Cobra 140GTL / 142GTL/ 148GTL Technical Bulletin 1226

Cobra Communications

TECHNICAL BULLETIN

Number 1226

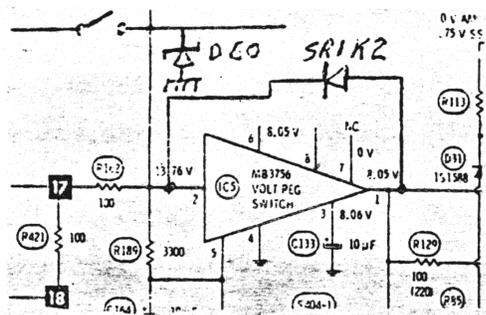
- TO:** ALL COBRA WARRANTY STATIONS
MODEL 140GTL - 142GTL - 148GTL.
- SUBJECT:** REGULATOR IC SHORTING OUT IN THE 140GTL, 142GTL, AND 148GTL. IC-5 (140, 142GTL), IC-4 (148GTL).
- SYMPTON:** HIGH AM POWER OUTPUT (10 WATTS) AND LOW MODULATION WEAK OR NO RECEIVE.
- SOLUTION:** REPLACE IC-5 (IC-4 FOR 148GTL) AND CHANGE D-60 (D-44 FOR 148GTL) TO A 18.2 VOLT ZENER DIODE. ADD A SR1K2 DIODE FROM PIN 1 TO PIN 2 OF IC-5 (IC-4 FOR 148GTL). (USE DIODE REMOVED FROM D-60/44).
- ADJUSTMENTS:** NONE REQUIRED.

DYNASCAN PART NOS. SR1K2 151-045-9-001
SUB. 16.2 VOLT ZENER 152-057-9-001. 18.2 VOLT ZENER (P/N N.A. AS YET)
TO BE USED WHEN IN STOCK

NOTE: THIS MODIFICATION SHOULD BE DONE ON ALL RADIO'S IN FOR IN-WARRANTY REPAIR. IF IC-5 (IC-4) CHECKS GOOD, ONLY MAKE DIODE CHANGES.
